HISTORIC AND DESIGN REVIEW COMMISSION

HDRC CASE NO: 2017-460
ADDRESS: 1110 BURNET ST
LEGAL DESCRIPTION: NCB 1665 BLK 1 LOT 12
ZONING: R-6, H
CITY COUNCIL DIST.: 2
DISTRICT: Dignowity Hill Historic District
APPLICANT: Felix Ziga/Ziga Architecture Studio
OWNER: Poma Properties, LLC
TYPE OF WORK: Rehabilitation; Rear Addition; Driveway; Rear Yard Fence
REQUEST:

HISTORIC REHABILITATION &
ADDITION
1110 BURNET ST.
SAN ANTONIO, TX 78202
POMA PROPERTIES, LLC

4 PROPOSED EAST ELEVATION
SCALE: 1/4"=1'-0"

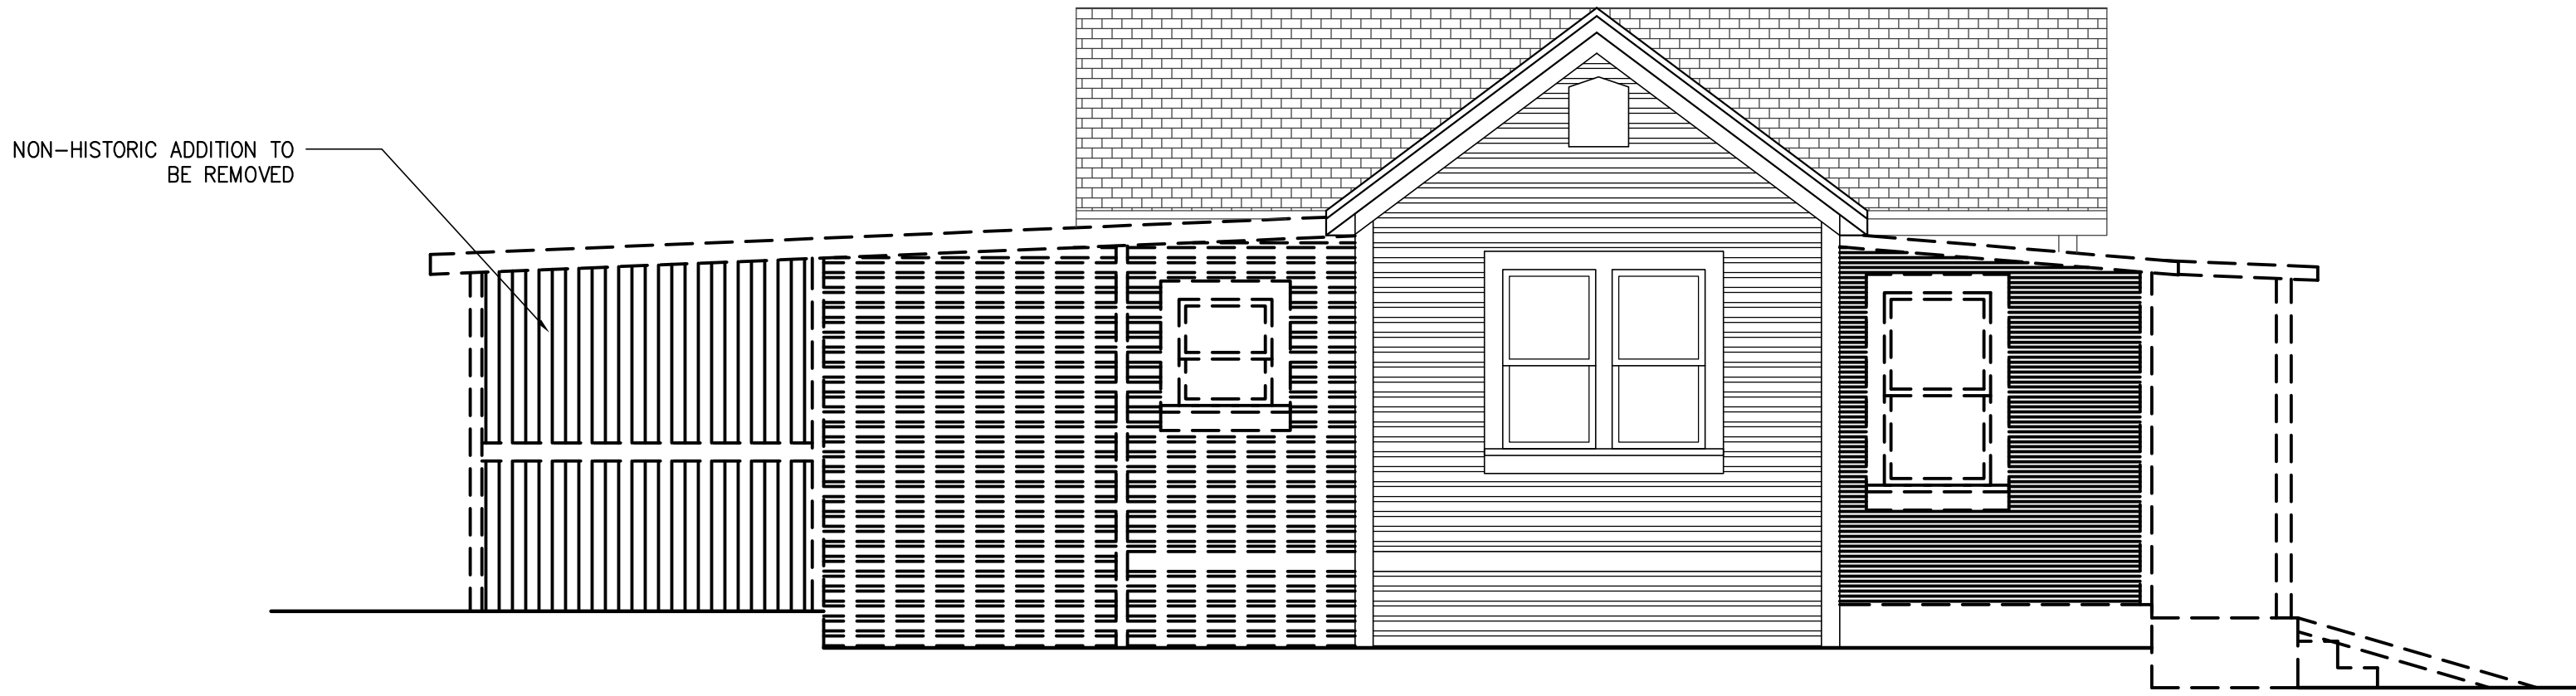
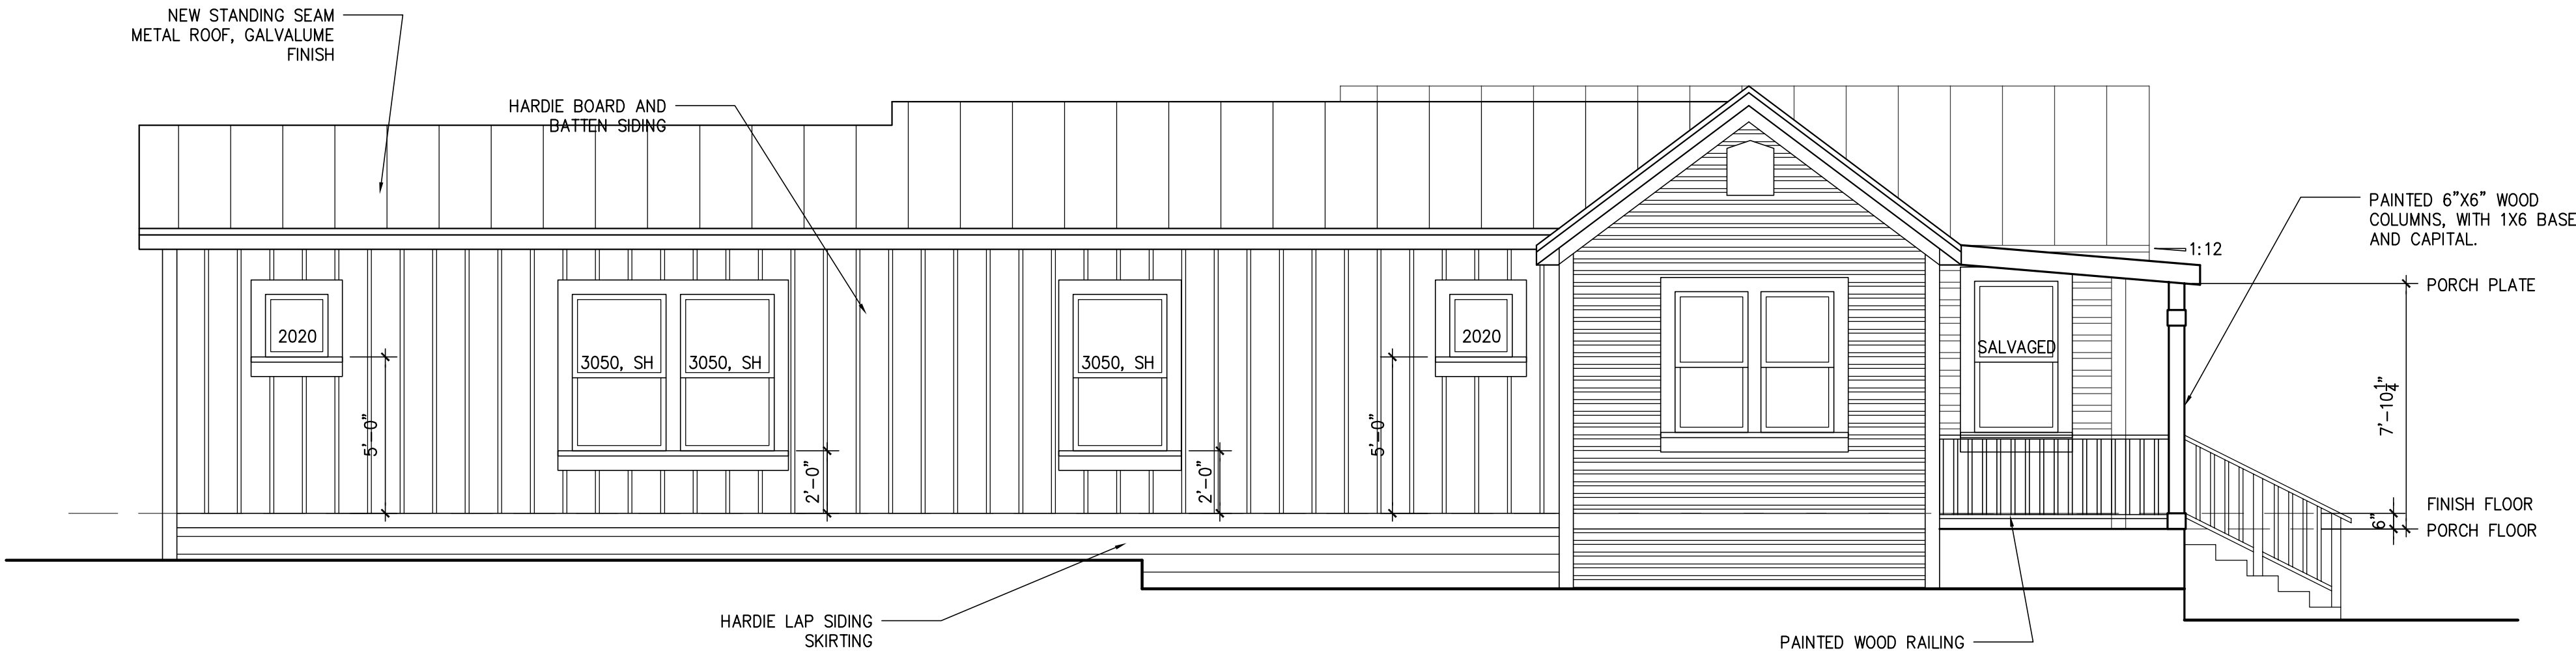
- g. **SCALE, MASS AND FORM** – Regarding footprint, the applicant has proposed for the addition to share a wall plane on the east façade that is the same as that of the historic structure. This addition would not comply with the side yard setback. Staff finds that an inset should be included to not only satisfy the Guidelines regarding a setback in wall planes, but also to comply with side yard setback regulations.

- h. **MATERIALS** – The applicant has proposed materials that include Hardi board and batten siding, a standing seam metal roof, Hardi lap siding for foundation skirting, wood lap siding and block frame vinyl windows. Staff finds that the proposed board and batten siding should feature boards that are twelve (12) inches wide with battens that

are 1 – ½” wide, horizontal siding should feature a four (4) inch exposure and that the standing seam metal roof feature panels that are 18 to 21 inches wide, seams are 1 to 2 inches in height, a crimped ridge seam and a standard galvalume finish. Staff does not find the use of block frame vinyl windows to be appropriate. Staff finds that wood or aluminum clad wood windows should be installed. White manufacturer’s color is not allowed, and color selection must be presented to staff. There should be a minimum of two inches in depth between the front face of the window trim and the front face of the top window sash. This must be accomplished by recessing the window sufficiently within the opening or with the installation of additional window trim to add thickness. Window trim must feature traditional dimensions and an architecturally appropriate sill detail. Window track components must be painted to match the window trim or concealed by a wood window screen set within the opening.

- ii. That an inset should be included to not only satisfy the Guidelines regarding a setback in wall planes, but also to comply with side yard setback regulations as noted in finding g.

- iii. That wood or aluminum clad wood windows be installed within the addition that adhere to the following standards: White manufacturer’s color is not allowed, and color selection must be presented to staff. There should be a minimum of two inches in depth between the front face of the window trim and the front face of the top window sash. This must be accomplished by recessing the window sufficiently within the opening or with the installation of additional window trim to add thickness. Window trim must feature traditional dimensions and an architecturally appropriate sill detail. Window track components must be painted to match the window trim or concealed by a wood window screen set within the opening.
